WALLARAH 2 COAL PROJECT
RESPONSE TO PLANNING ASSESSMENT COMMISSION REVIEW REPORT
for
Wyong Areas Coal Joint Venture

Plate 1
Natural Avulsions and Meander Cutoffs

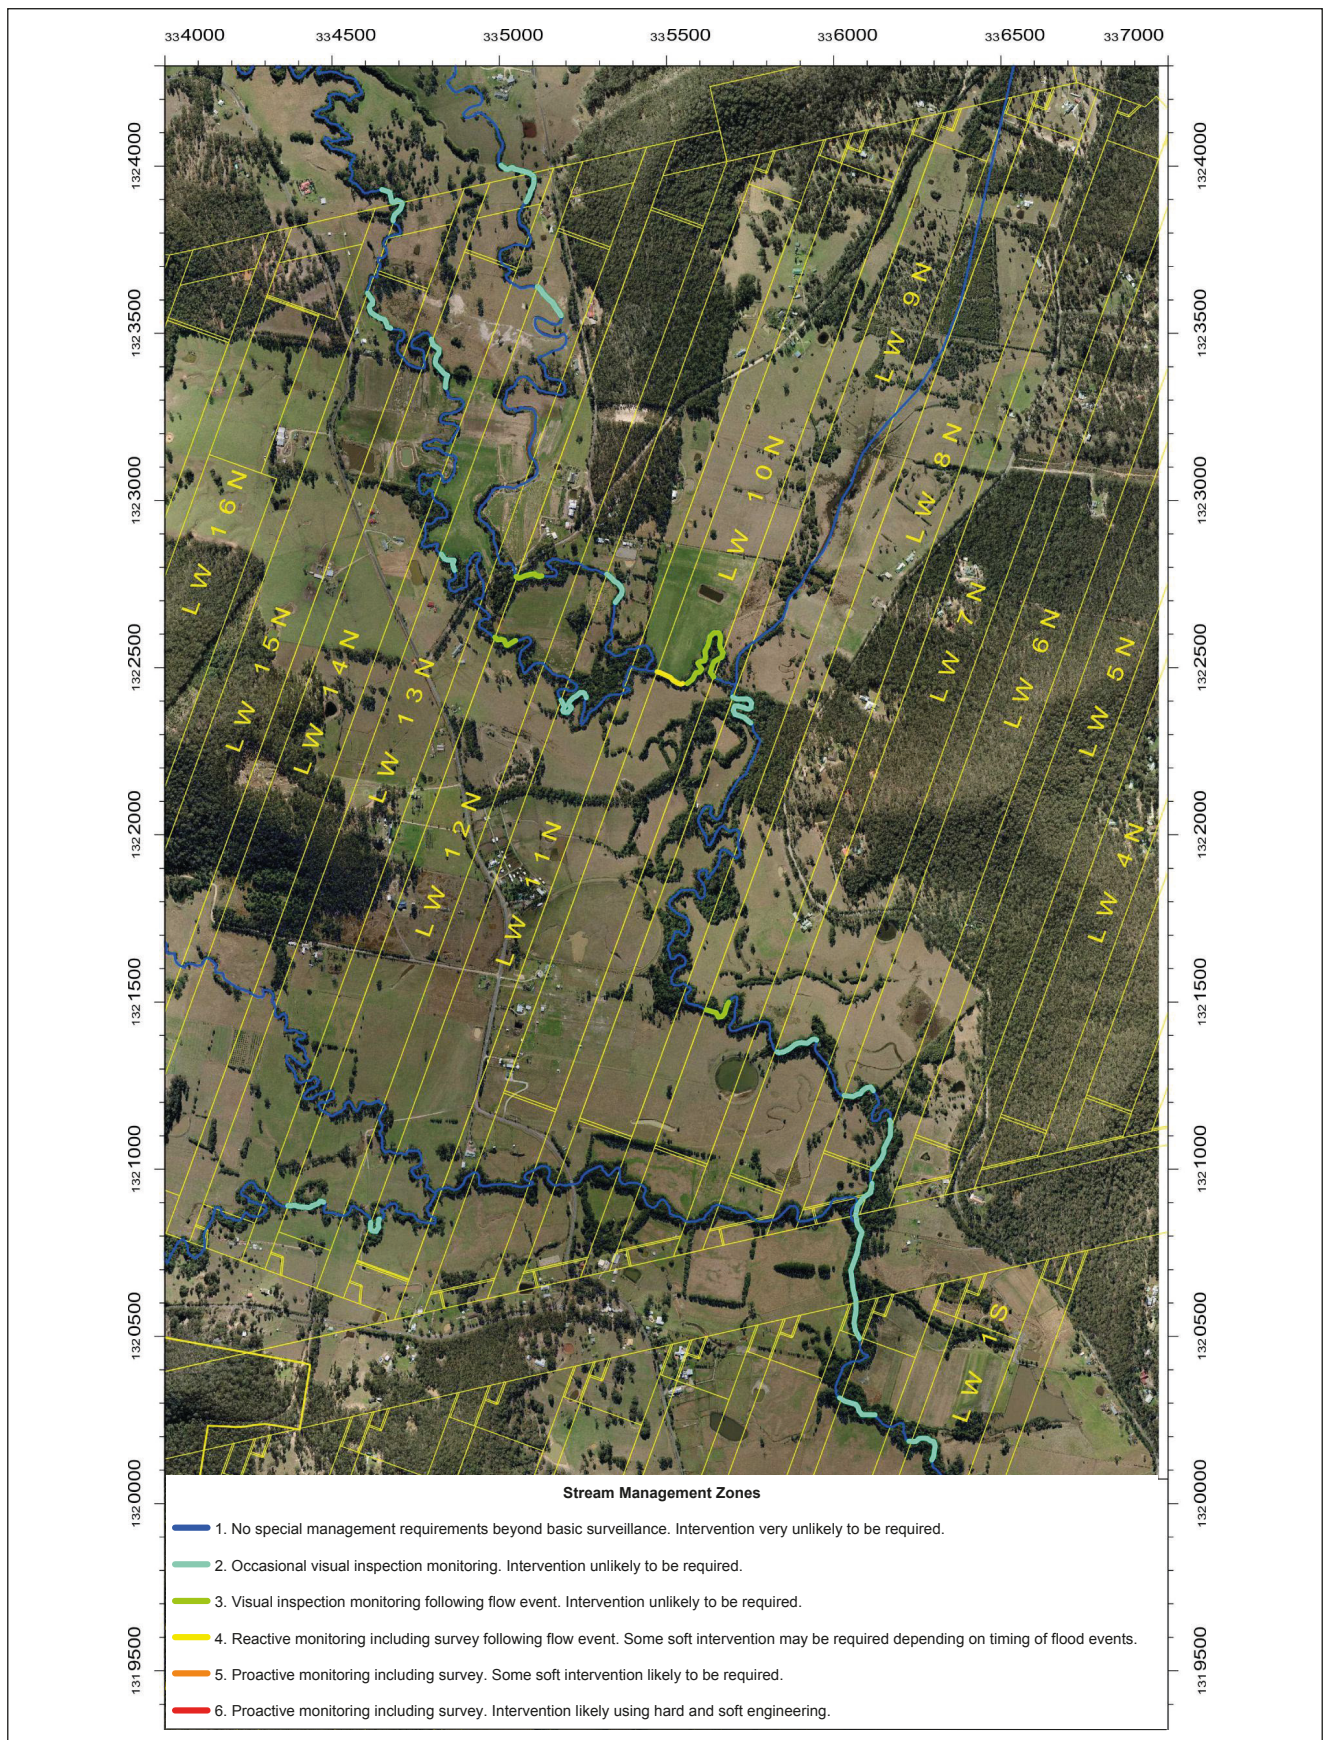
Given that the existing alluvial stream system is dynamic, baseline and ongoing monitoring is a key element of identifying subsidence related impacts. Examples of naturally occurring changes to stream morphology are shown in **Plate 1** and **Plate 2**. The monitoring program will include measurements and inspections of ground levels, vegetation, ecology, water quality and groundwater.

Proactive soft intervention, such as improvement of bank vegetation, may be undertaken where areas of potential elevated subsidence impact coincide with existing geomorphic instability. An example of soft intervention is shown in **Plate 3**. WACJV will consult with owners of land where potential impacts to streams may occur. These issues will be addressed in the Property Subsidence Management Plans for these properties.
